# Application to AMEND a Planning Permit

Planning Permit No.: 12/0317

**RFI Request – Application No: 12/0317G**  
**40 The Esplanade, Torquay**

PROJECT TITLE:  
**PROPOSED RETAIL & RESIDENTIAL DEVELOPMENT**  
 AT:  
**40 THE ESPLANADE TORQUAY 3228**

DRAWING TITLE:  
**TOWN PLANNING SECTION 72 AMENDMENT ELEVATIONS 02**

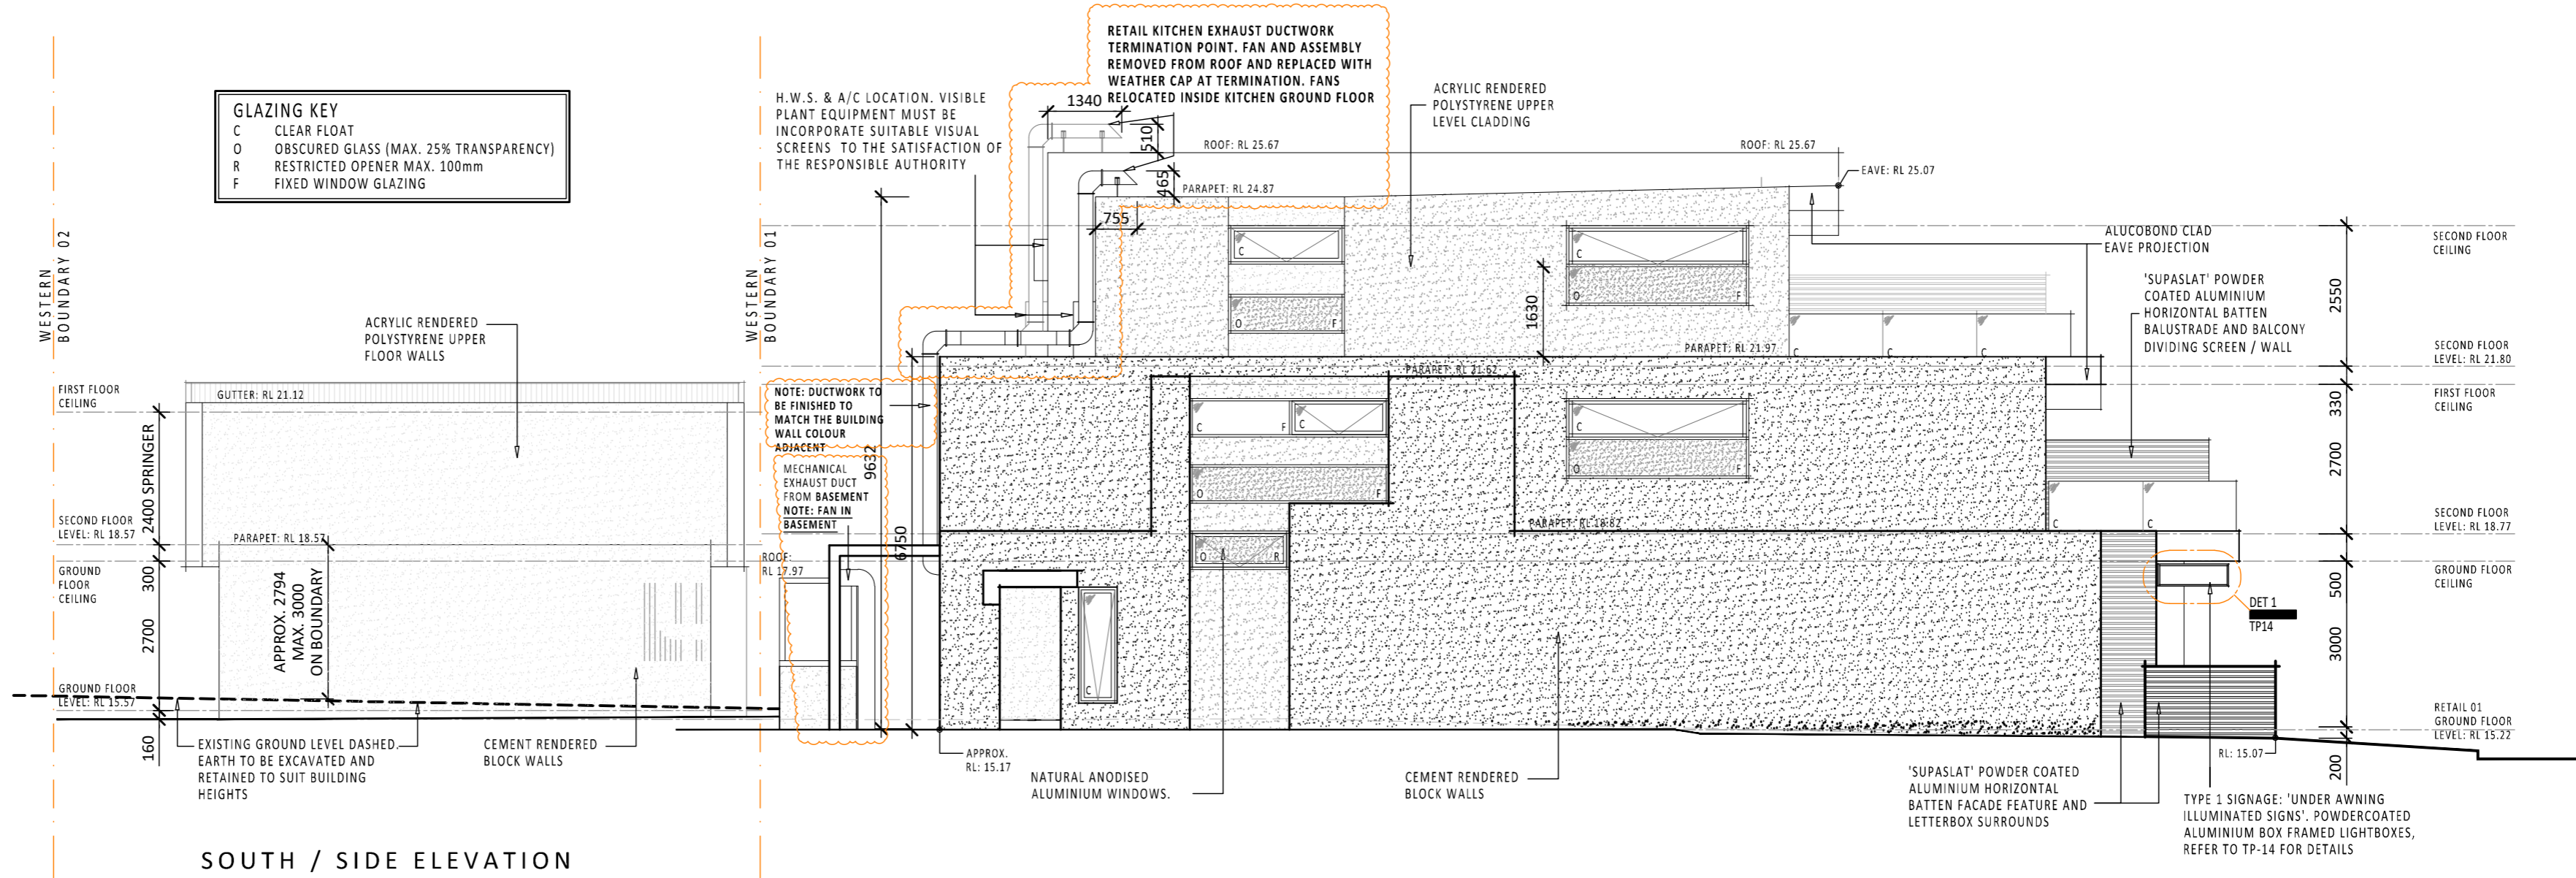
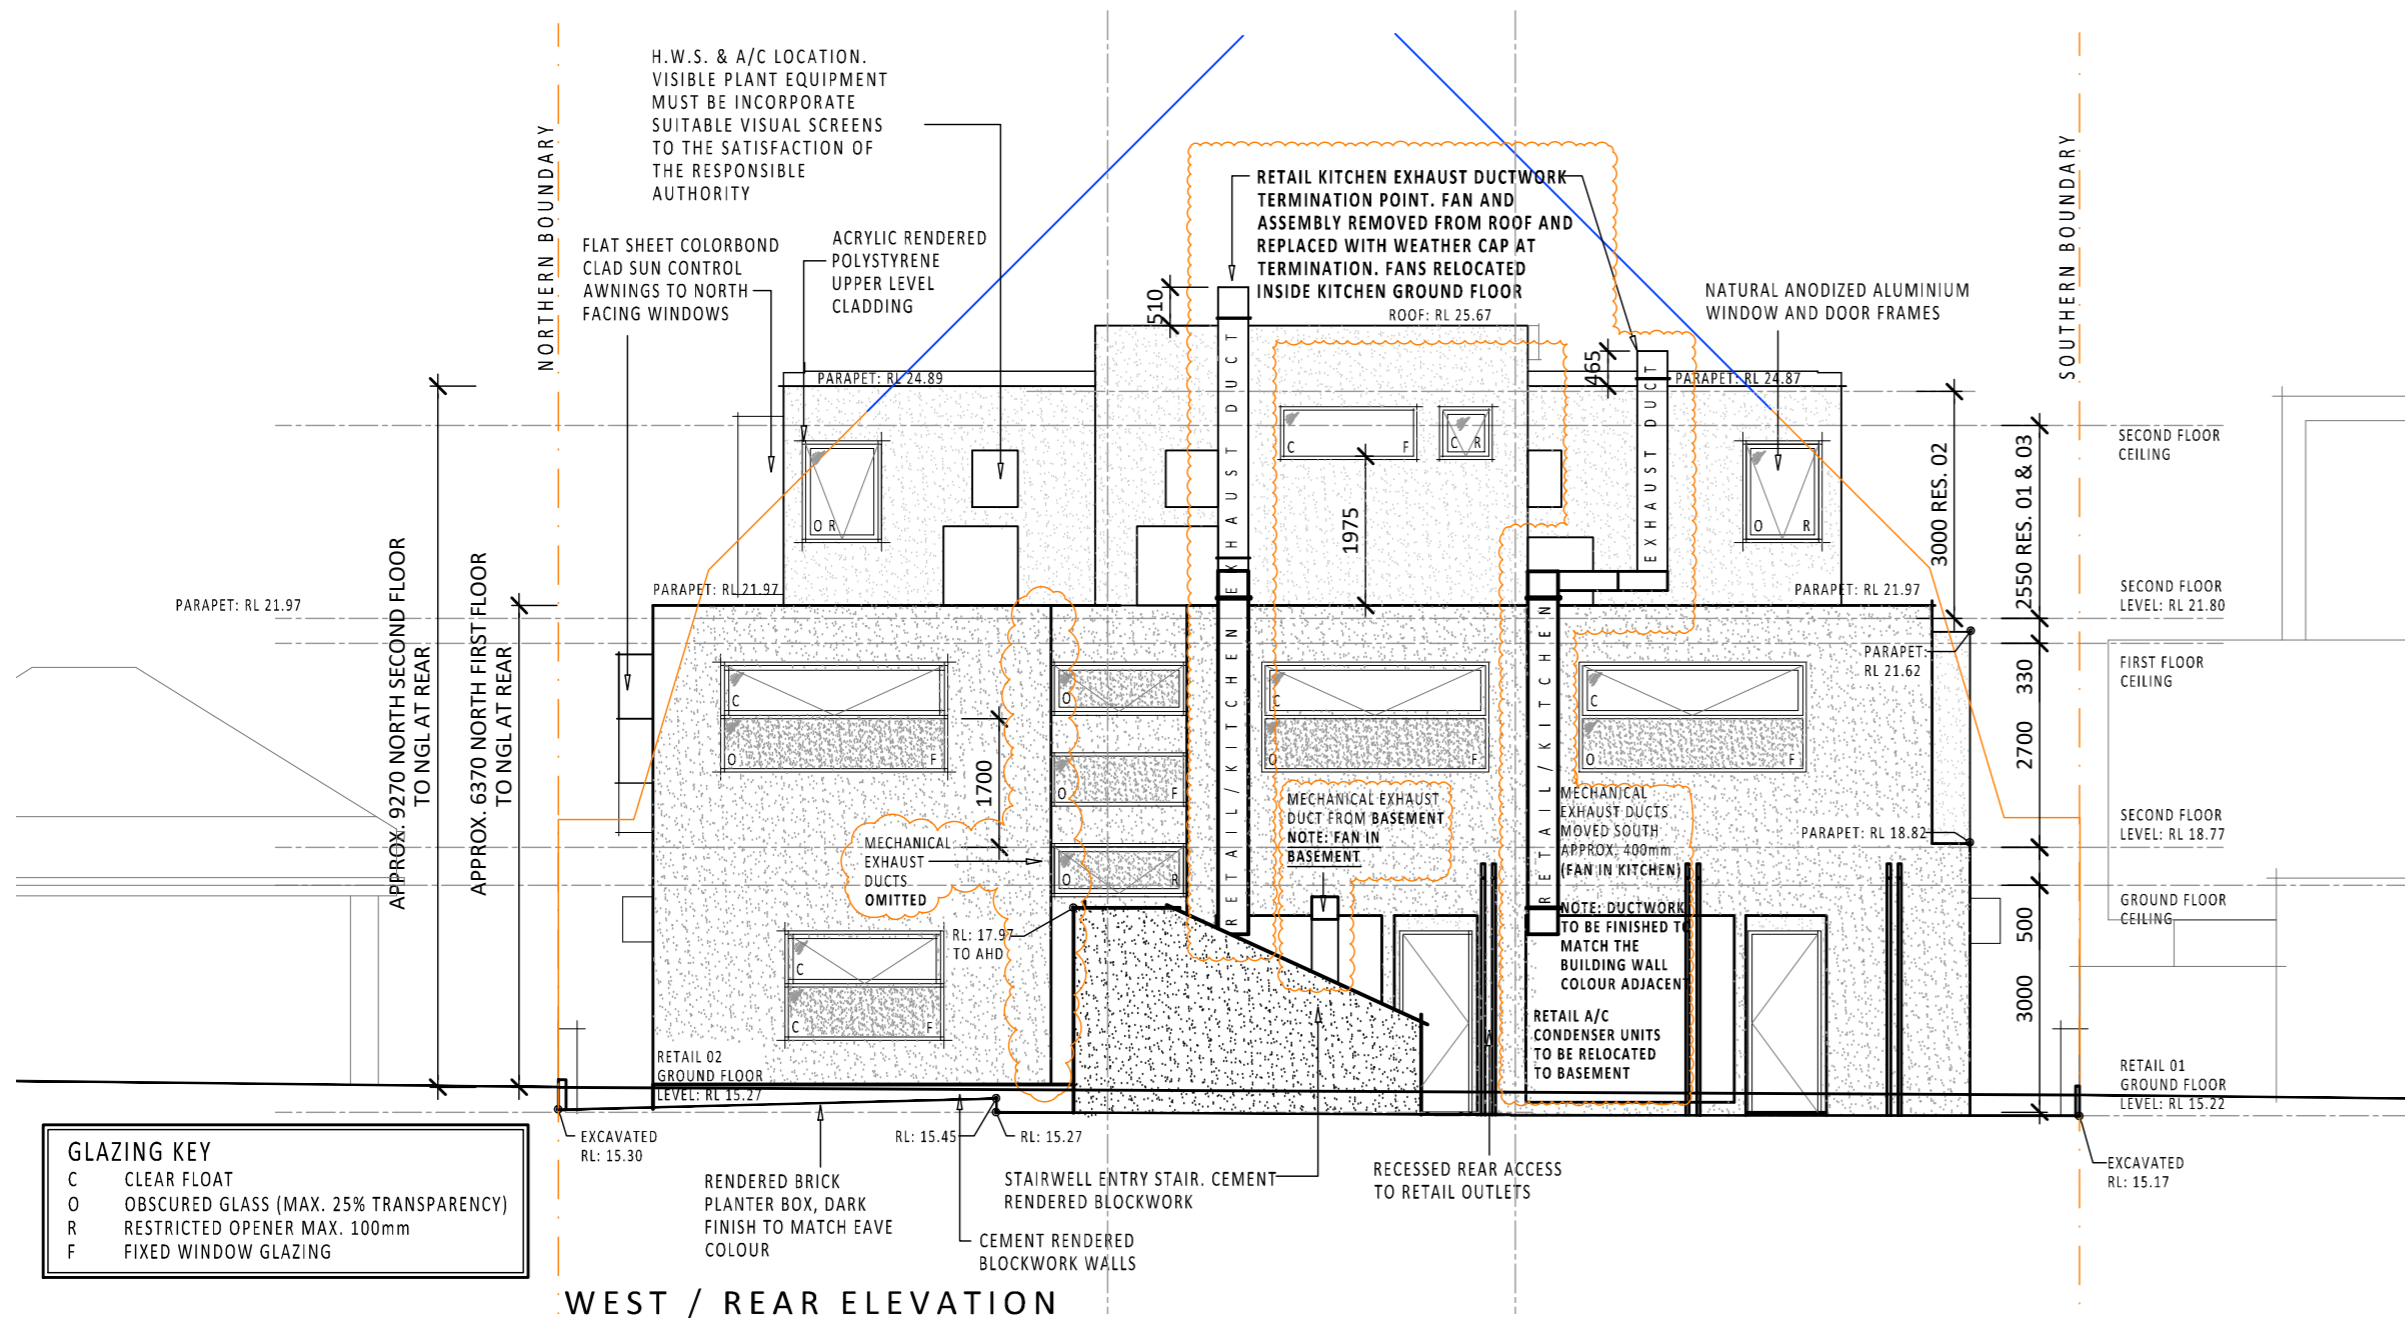
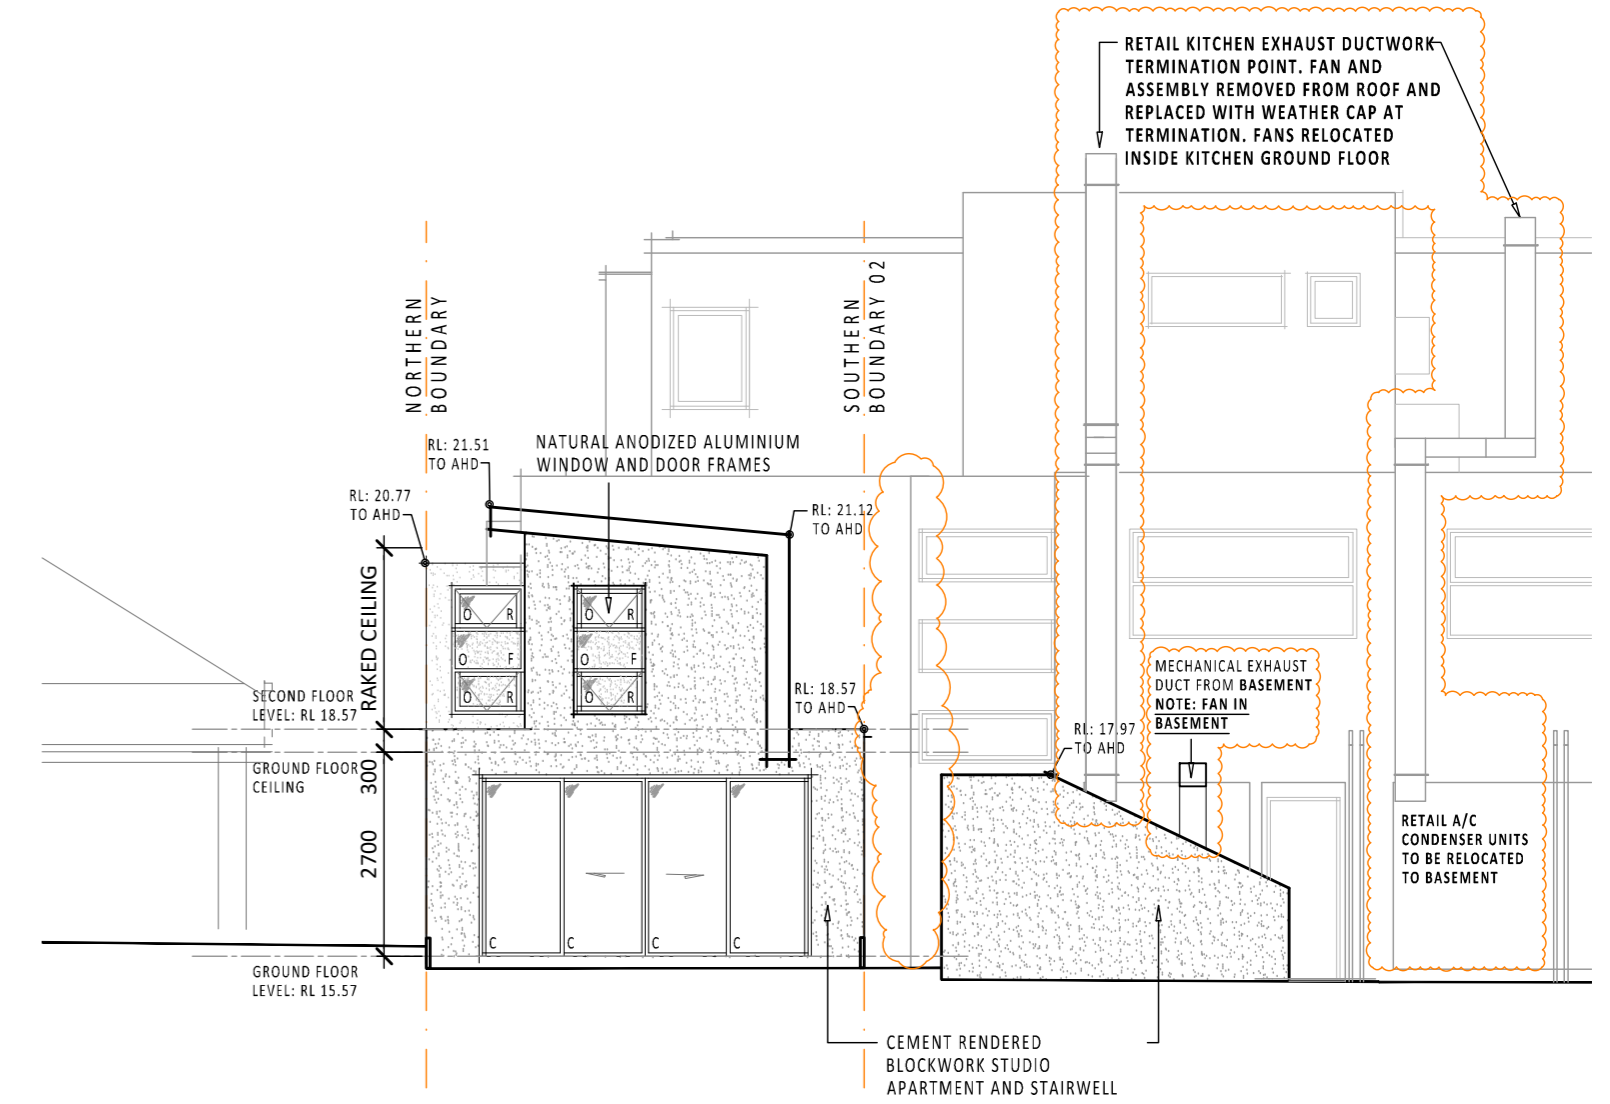
13.03.13	RETAIL AREAS REVISED. RLs NOTED.		
18.01.17	ACOUSTIC REQUIREMENTS NOTED	A	NC
27.04.17	SECTION 72A	C	NC
18.07.17	SECTION 72. FAN REMOVED FROM ROOF SOUTHERN DUCT POSITION CORRECTED	D	NC
	FOLLOWING SITE INVESTIGATION, A/C UNITS RELOCATED, DUCT COLOUR SPECIFIED, ACOUSTIC NOTES UPDATED	E	NC
DATE:	REVISION:	No.	BY:

DRAWING TITLE:  
**TOWN PLANNING  
 SECTION 72 AMENDMENT**  
**SECTION B-B**

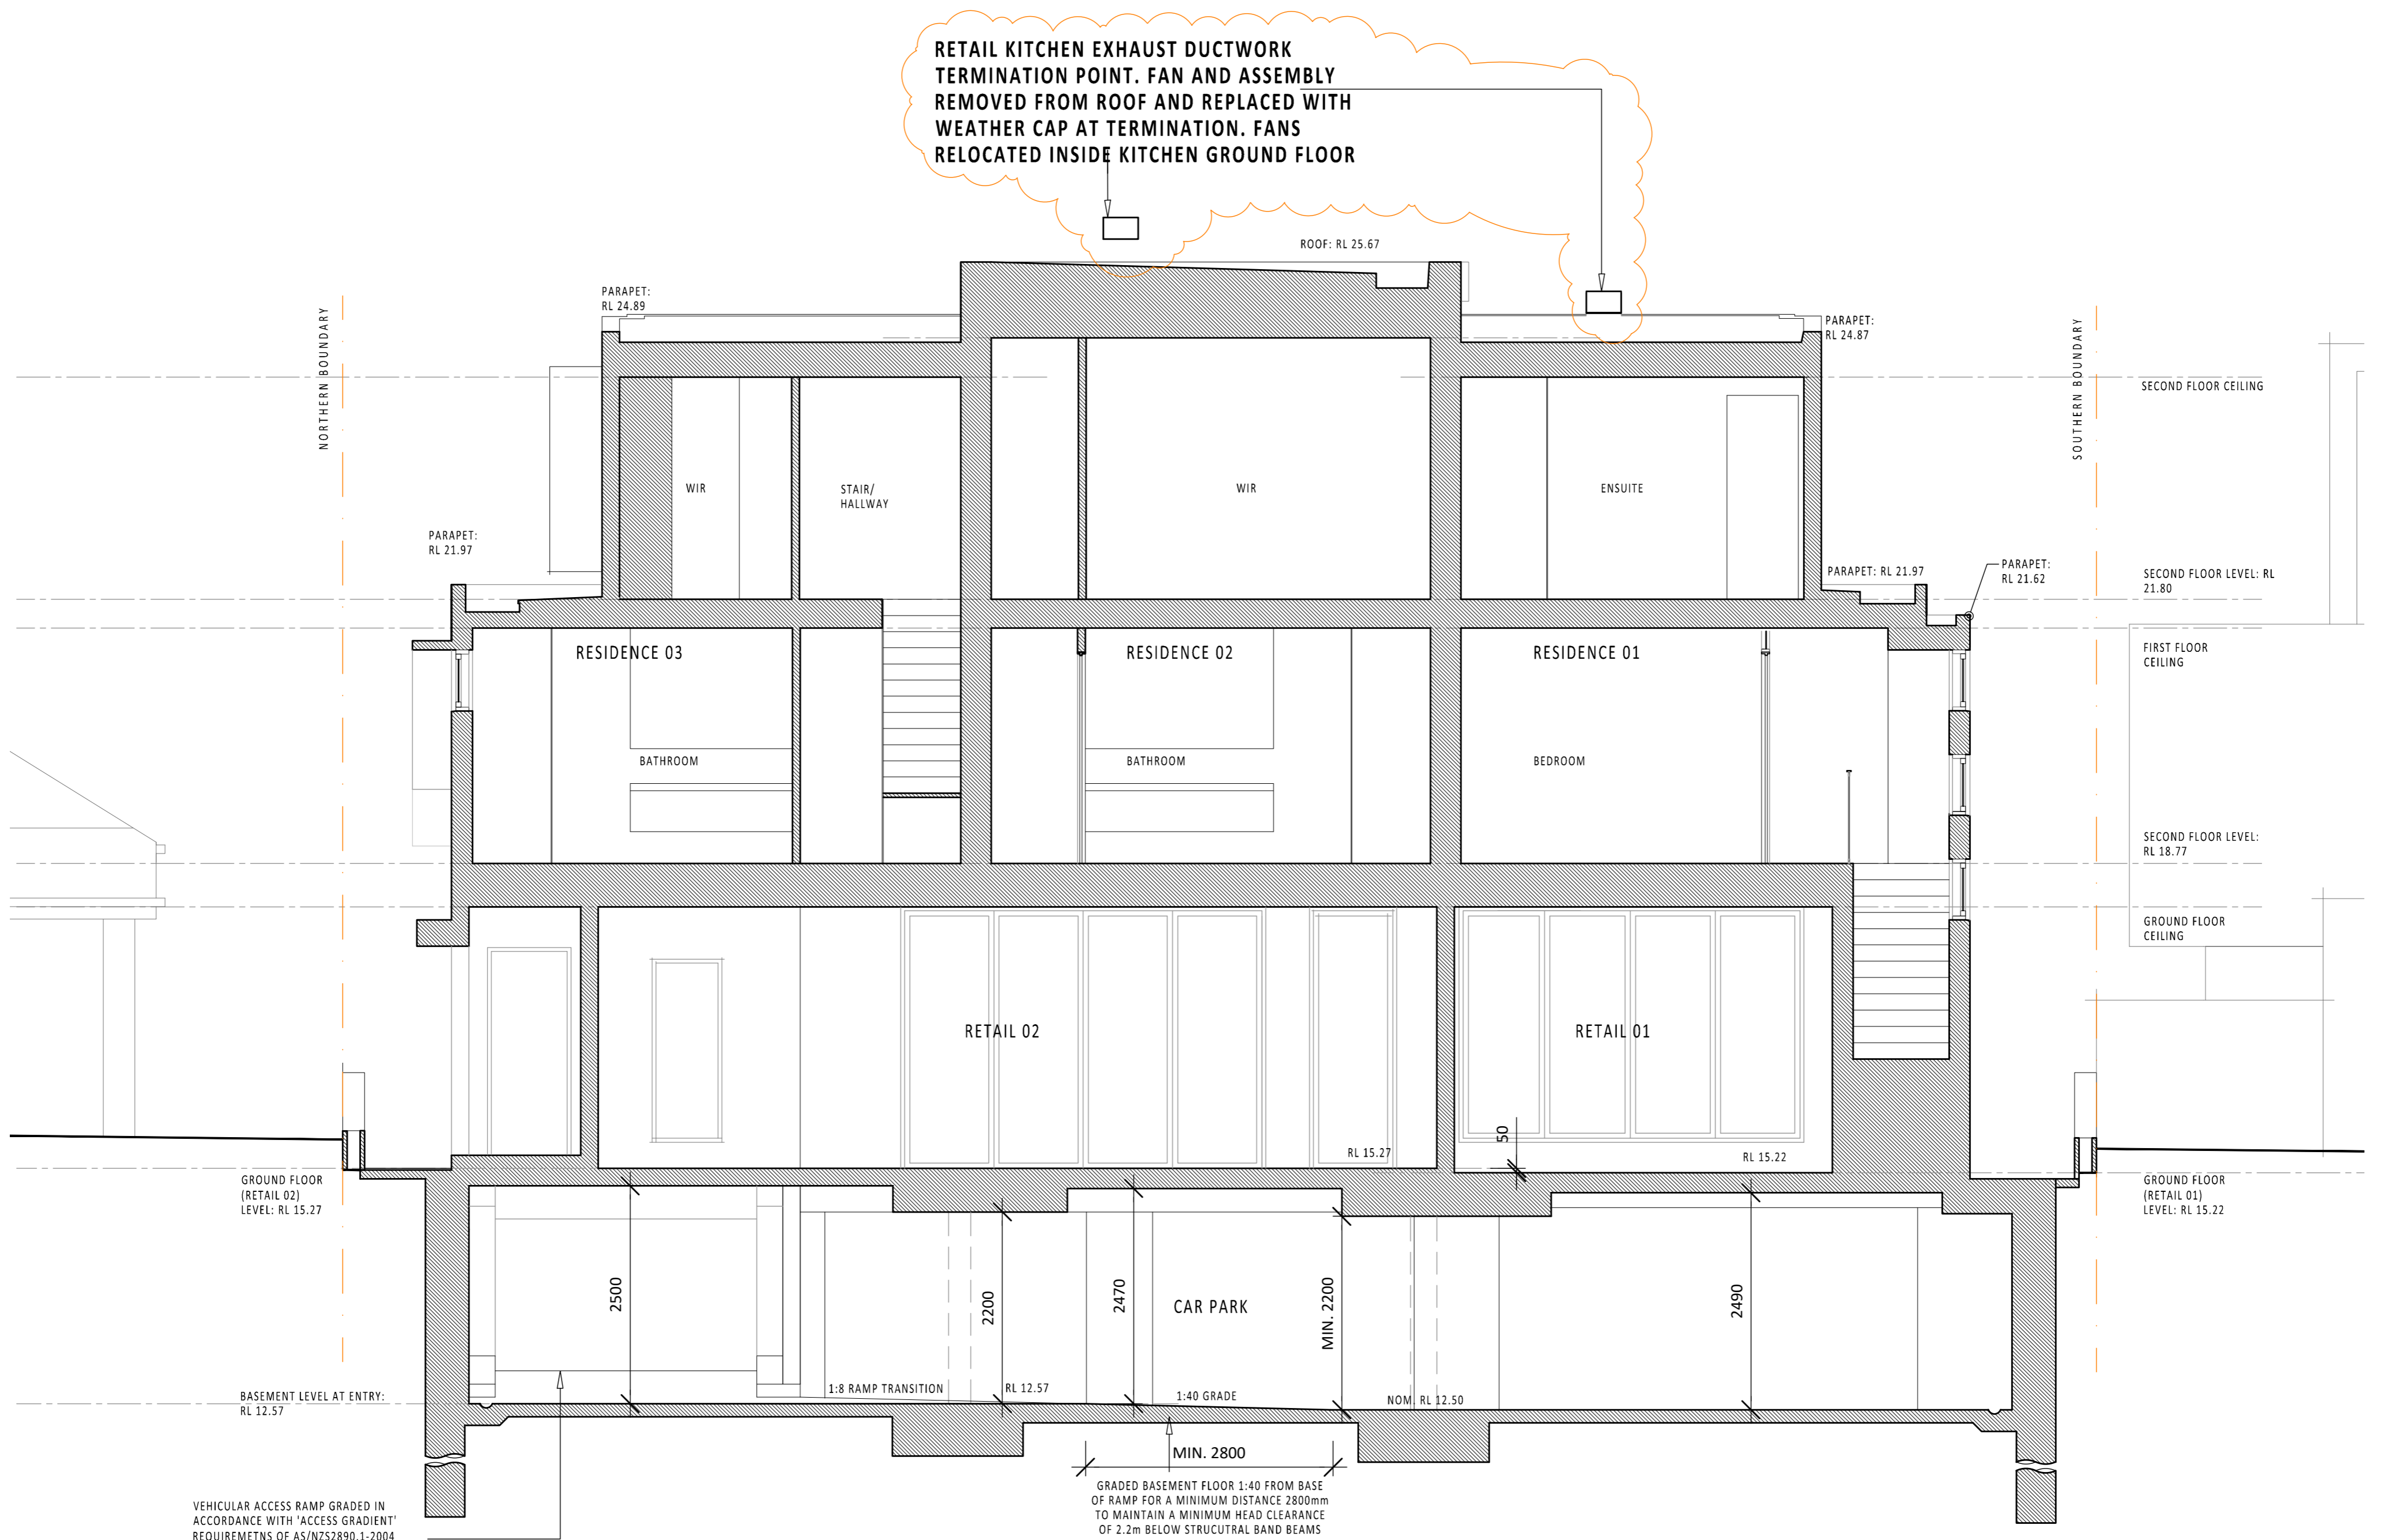
RETAIL KITCHEN EXHAUST DUCTWORK  
 TERMINATION POINT. FAN AND ASSEMBLY  
 REMOVED FROM ROOF AND REPLACED WITH  
 WEATHER CAP AT TERMINATION. FANS  
 RELOCATED INSIDE KITCHEN GROUND FLOOR

13.03.13	RETAIL AREAS REVISED. RLs NOTED.		
18.01.17	ACOUSTIC REQUIREMENTS NOTED	A	NC
27.04.17	SECTION 57A	C	NC
18.07.17	SECTION 72. FAN REMOVED FROM ROOF	D	NC
	SOUTHERN DUCT POSITION CORRECTED		
	FOLLOWING SITE INVESTIGATION, A/C		
	UNITS RELOCATED, DUCT COLOUR		
	SPECIFIED, ACOUSTIC NOTES UPDATED	E	NC
DATE:	REVISION:	No.	BY:
